#### FIELD SERVICE BULLETIN 101

21 July 2010

**SUBJECT:** Nose Gear Fork Inspection

EFFECTIVITY: All D-16 & D-16A Twin Navion aircraft, Serial

Twin Navion Nose Gear Fork Reinforcement		Part Number:
Field Service Bulletin 101	7-21-2010	145-34117-1003
American Navion Society, Ltd.		Drawing No. A

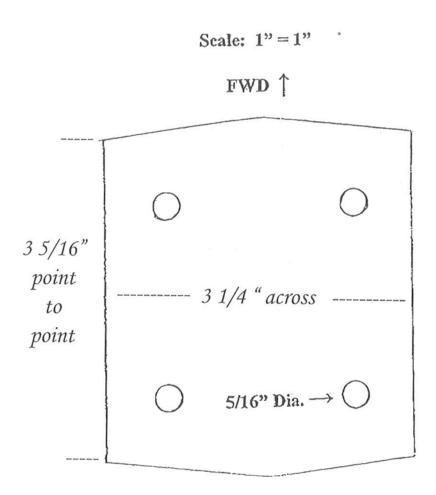
1. Reinstall fork with 145-34117-1002 reinforcement plate on underside of fork. Lateral edges of plate may have to contoured to fit contour of the nose fork. Install new longer AN bolts to compensate for

thickness of plate. Reinforcement plate spreads load of bolt heads over a much larger area of the fork than the AN960-5 washers. The plate is a preventative repair measure and not a repair for a cracked fork.

- 2. Mud scrapper 145-34153 is installed on underside of reinforcement plate, and may need the curved area radius enlarged with a die grinder for proper clearance of tire, according to tire diameter.
- 3. Plate 145-34117-1002 specifications are shown in Drawing A.
- C. AIRCRAFT RECORDS: Enter in aircraft records date of inspection, aircraft hours, results of the inspection, and hours and/or date next inspection is due.

1/4" 2024-T3 Plate

Contour upper surface of plate to mate with contoured surface of fork

FIG. 1

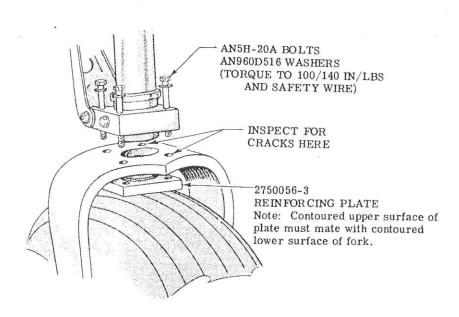
d. If the fork is deemed serviceable or a new fork is being installed, the retaining bolts and nuts should be torqued to a value of 100/140 in/lbs. It is recommended that the original AN365-524 fork retainer nuts be replaced. In the event the new 2750056-3 plate is being installed the same torque value will apply and the plate should be installed as shown in Figure I.

It will not be possible to use a mud scraper when the 2750056-3 plate is installed.
